Ajax Project Review - Review of Predicted Water Contamination

Sierra Club of BC Foundation
301 - 2994 Douglas Street,
Victoria, British Columbia V8T 4N4

Kevin A. Morin, Ph.D., P.Geo., L.Hydrogeo.
Minesite Drainage Assessment Group
A Division of Morwijk Enterprises Ltd.
Surrey, British Columbia
www.MDAG.com

March 31, 2016

Figure 4-1. A schematic comparison of typical testwork with humidity cells, columns, and in-field tests to typical full-scale reality in waste rock, tailings, and mine walls, showing that reality at Ajax can produce much higher concentrations than typical testwork.

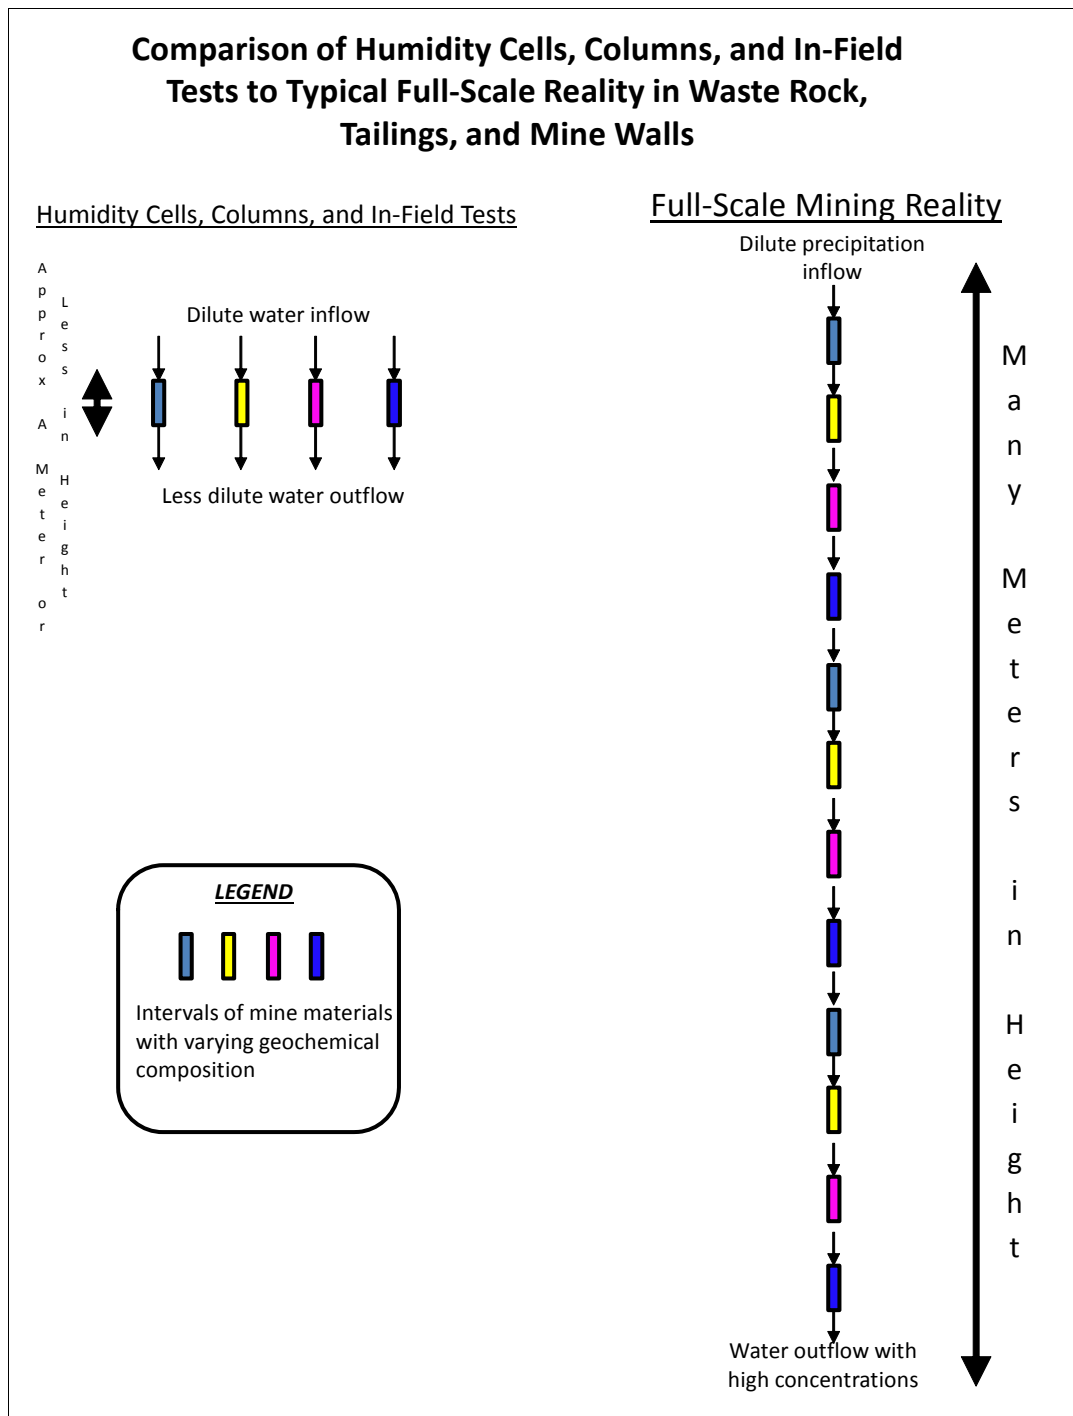
Do such tests reasonably reflect water quality under full-scale mining conditions, or can they severely underestimate it? A simple way to answer this question is with a diagram, as shown in Figure 4-1.

The testwork in Appendix 3-A put water through samples about 1 m in height or less (left side of Figure 4-1). At the proposed Ajax site, the waste-rock dumps would have heights of 85-270 m, and the waste-rock tailings embankments would be 10-122 m high (longer than the right side of Figure 4-1)! Would you expect concentrations in water that has passed through 100 m of rock to be higher than concentrations that passed through less than 1 m? I see they could be much, much higher.

As a result, the many comparisons of test results in Appendix 3-A to British Columbia water-quality guidelines are meaningless, because all we can surmise is that the real on-site source concentrations could be much higher and thus more contaminated to some unknown degree. Alarming, some concentrations from the short-length kinetic tests even surpassed provincial water-quality guidelines, so real on-site source contaminant concentrations could be highly toxic.

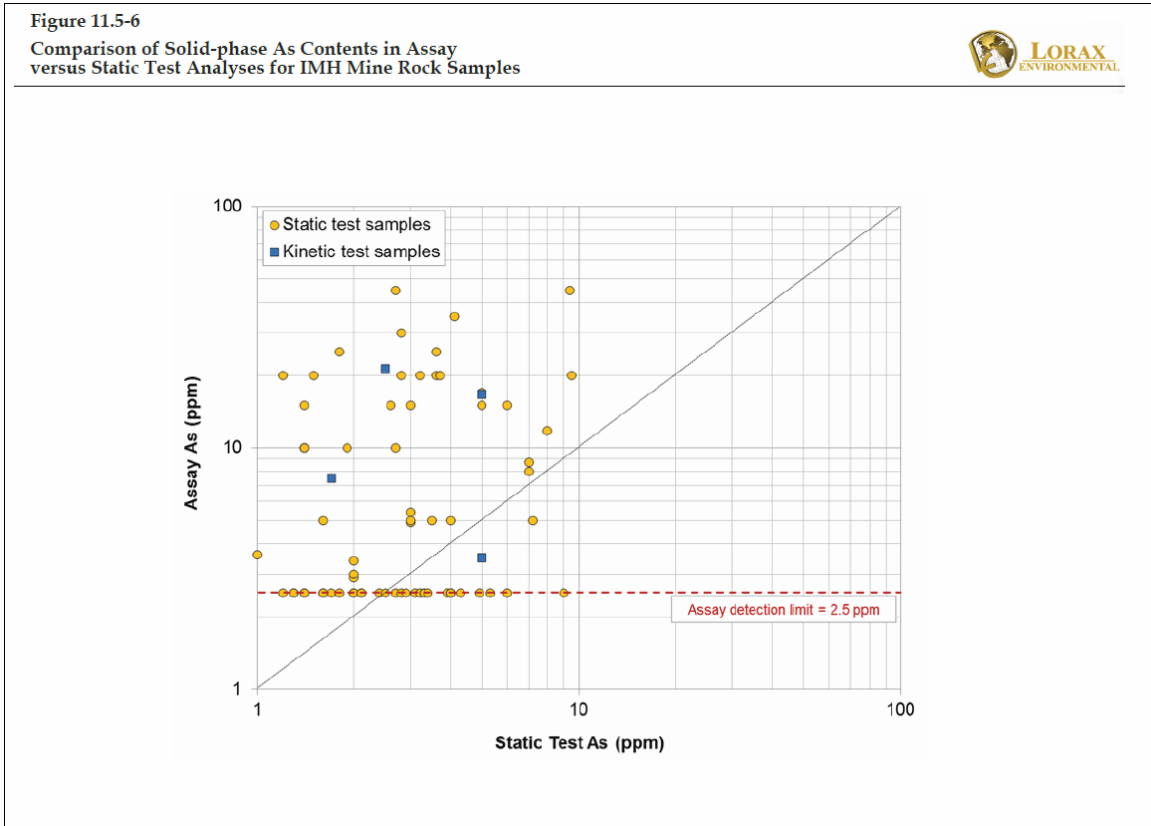
However, there is a telling clue to how extreme the differences are between the high assay values and the low the environmental values. Section 11.5.3.7 explains that solid-phase arsenic can affect how much arsenic is released to water and thus how contaminated the water can become. Figure 11.5-6 (reproduced in this review for convenience as Figure 4-2) then shows that the real, assay values are often greater than 10 ppm and approach 50 ppm (along the y-axis). In remarkable contrast, the corresponding environmental “static test” samples (along the x-axis) do not exceed 10 ppm and are often less than 4 ppm. There can be a difference of a factor of 10 or more. Again, the EIS, its estimates of contamination, and estimated of risk to humans and the environment are all based on the low, partial digestion values. Thus, environmental effects and risks may be underestimated by a factor of 10 or more in the EIS!

This approach and its underestimation of effects and risks are not precautionary (see Section 1 of this review), may not lead to non-zero harm, and may not even be reasonable. Nevertheless, KAM refuses to release the assay database.

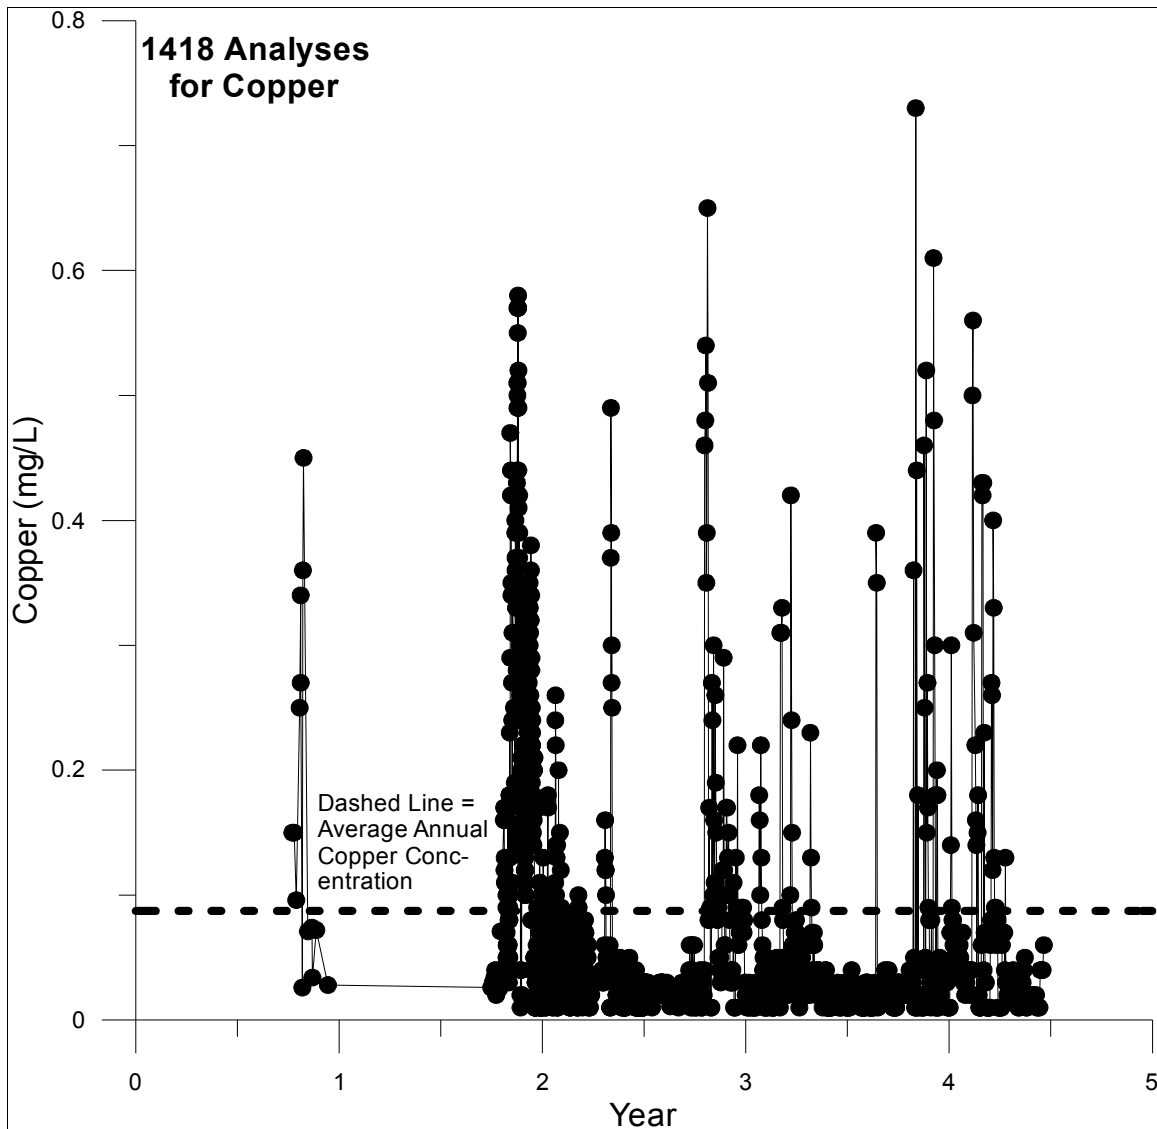
A simple illustration of this is in Figure 4-3 in this review. Figure 4-3 is based on real, full-scale near-neutral drainage, from waste rock, at a British Columbia copper minesite. In fact, this minesite is one of those in the special SRK database that Ajax chose for capping its maximum concentrations. This figure shows that the average annual concentration (0.0874 mg/L at the horizontal dashed line) can be exceeded for weeks or months each year, to levels that would be toxic to aquatic life. The horizontal dashed line in Figure 4-3 is how the Ajax EIS predicts high peaks in contaminant levels, whereas the solid, highly variable line shows reality with toxicity events.

For surface drainages into ditches and ponds, there might be some smoothing, but pulses of elevated contamination above average annual would still occur. In fact, Figure 4-3 shows real, full-scale pulses in a ditch draining waste rock. Perhaps if the ponds had retention times (holding all water entering them) for an entire year with no release, then the average annual might apply. However, this is not the plan for Ajax surface drainages and ponds according to the EIS.

Prominently missing from these predictions of concentrations in Appendix D are the nitrogen species, so no one can judge whether they are of concern. Despite the missing predictions, Appendix C does include caps, but only for the TSF Pond. These unrealistically low caps were discussed above.
